DEPARTMENT OF GENERAL SERVICES BUREAU OF CAPITAL PROJECT DESIGN MANAGEMENT 1800 HERR STREET HARRISBURG, PENNSYLVANIA

ADDENDUM NO. 2

PROJECT NO. DGS C-0199-0038 PHASE 001
PROJECT TITLE - Belmont Lake Dam - Belmont Lake Dam Upgrades
PROFESSIONAL:

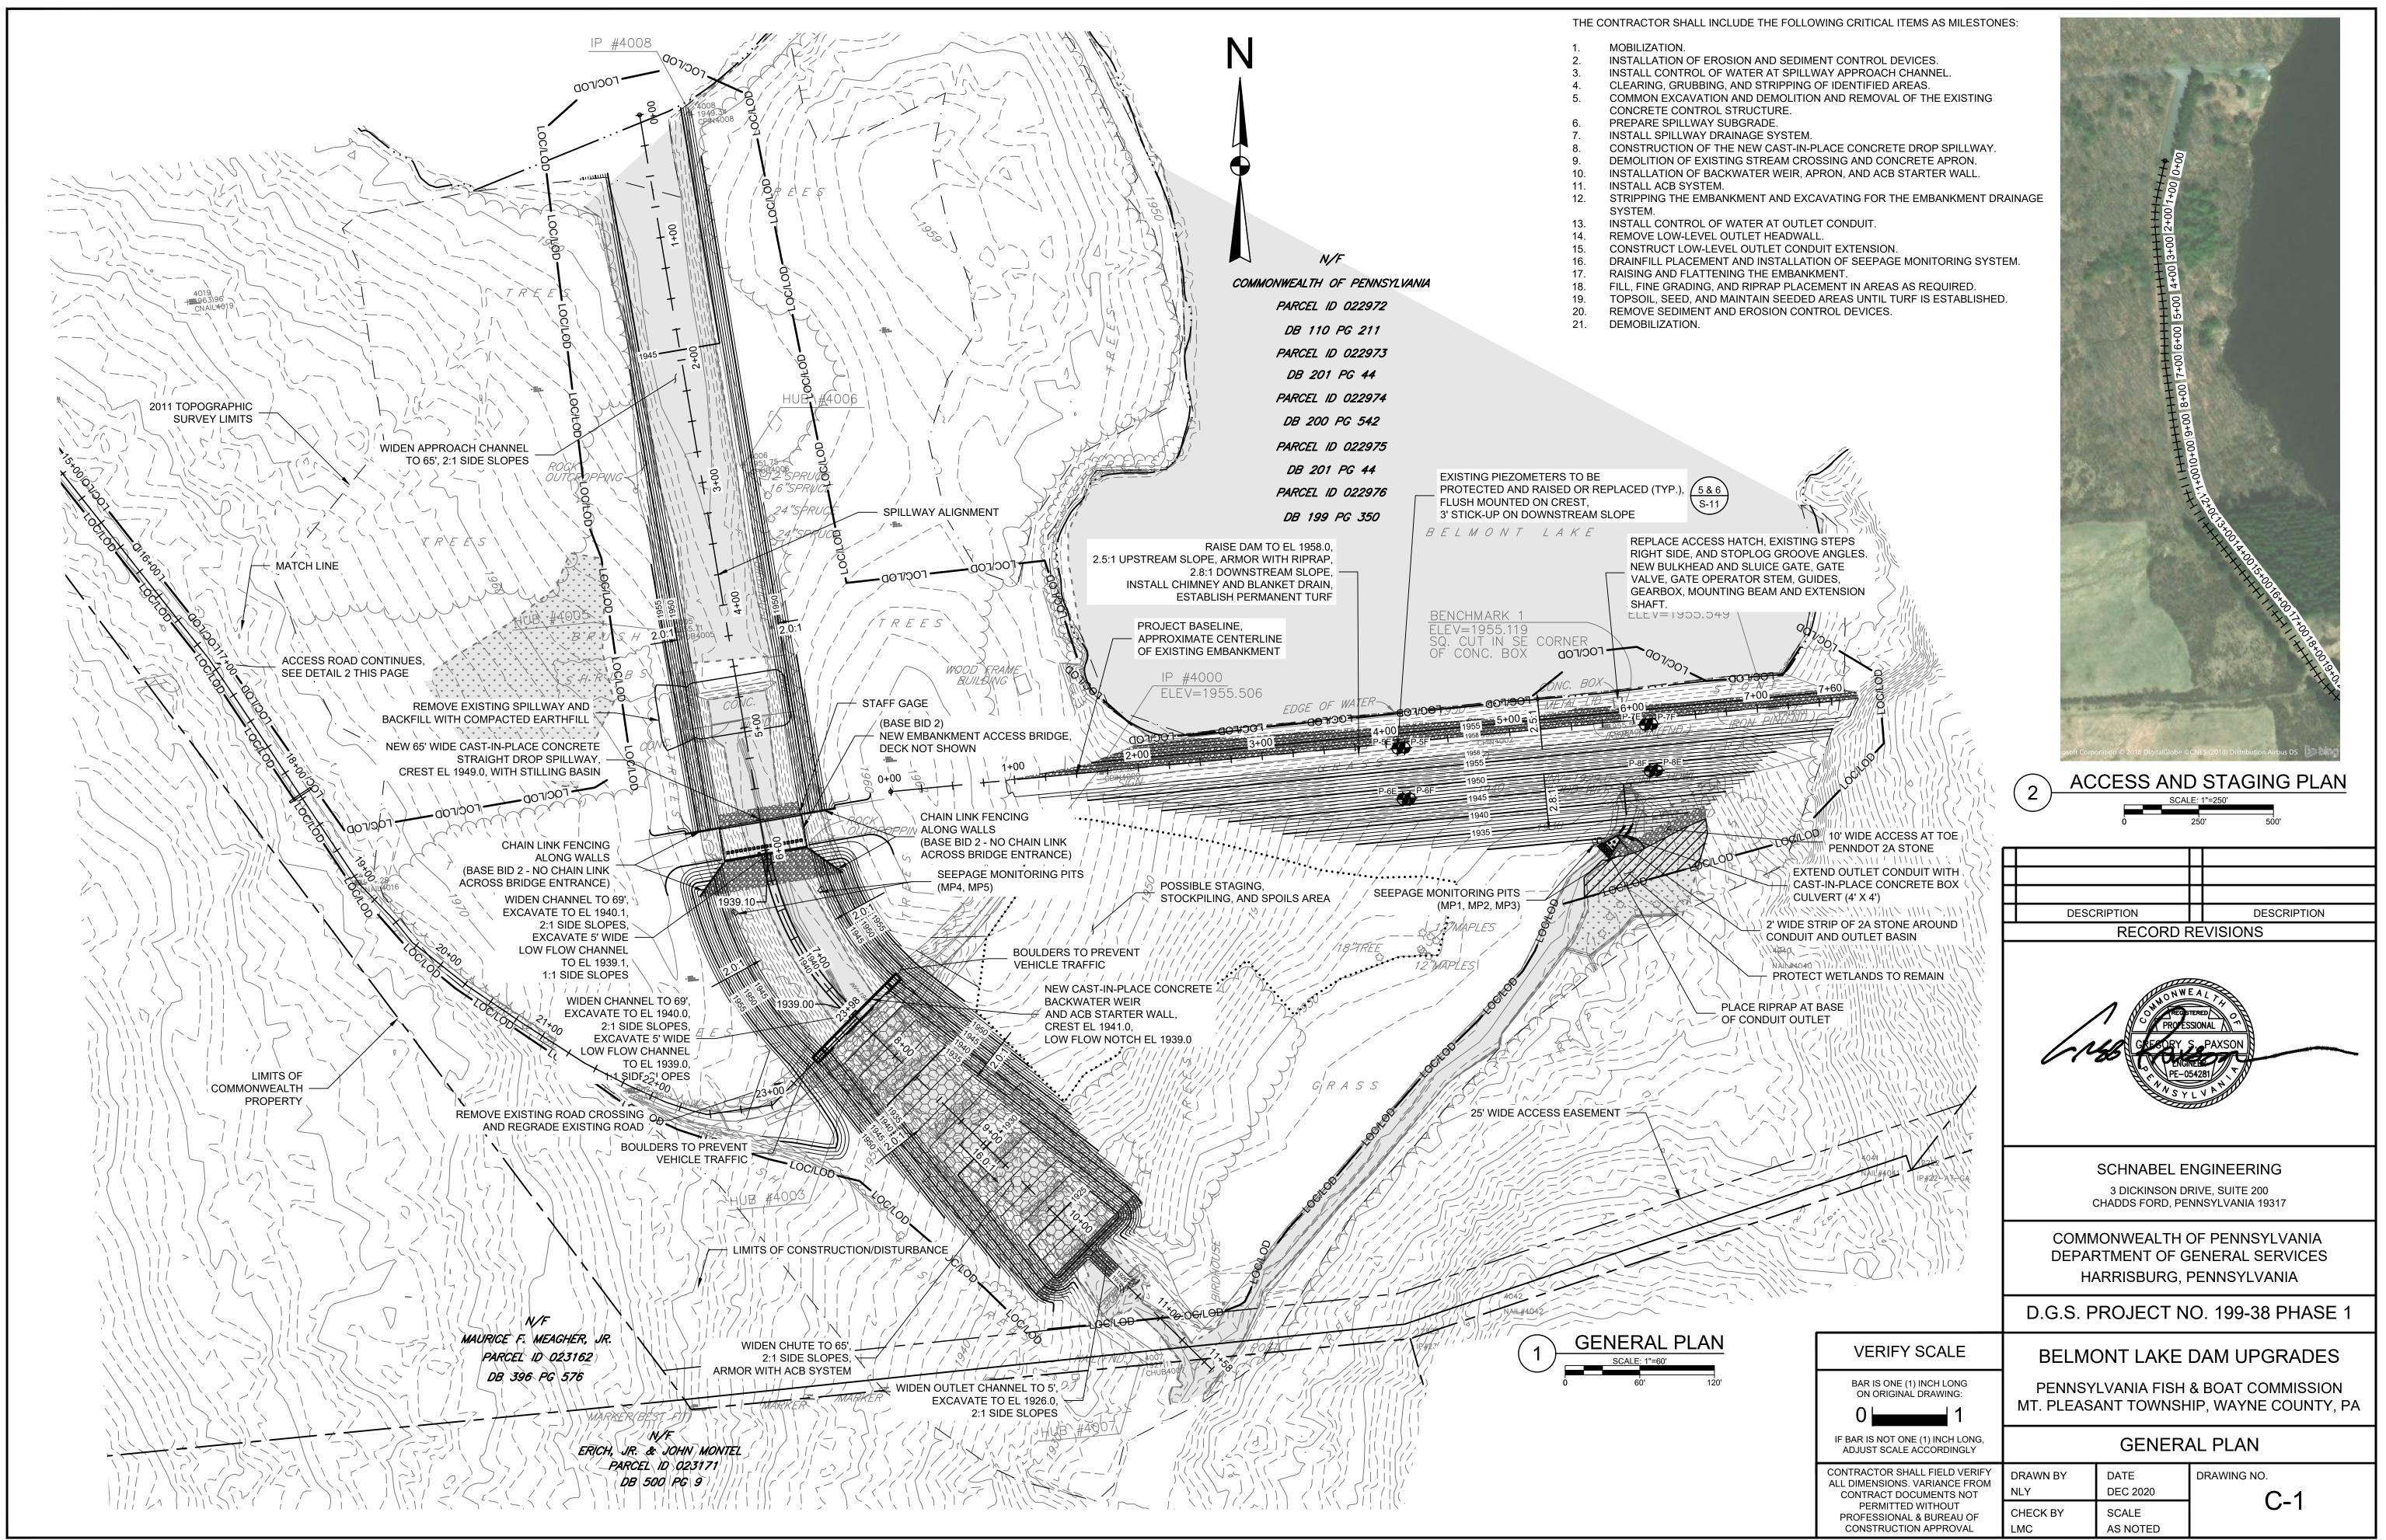
- Item 1 Drawings C-13, Spillway Drainage Plan, and C-14, Spillway Drainage Profile & Details shall be added to the Contract Drawings
 - Item 2 Drawing C-1, General Plan, has been revised to include riprap upstream of the new cast-in-place

straight drop spillway. Item 3 – Drawing ES-1, E&S Plan, has been revised to include riprap upstream of drop spillway.	the new cast-in-place straight
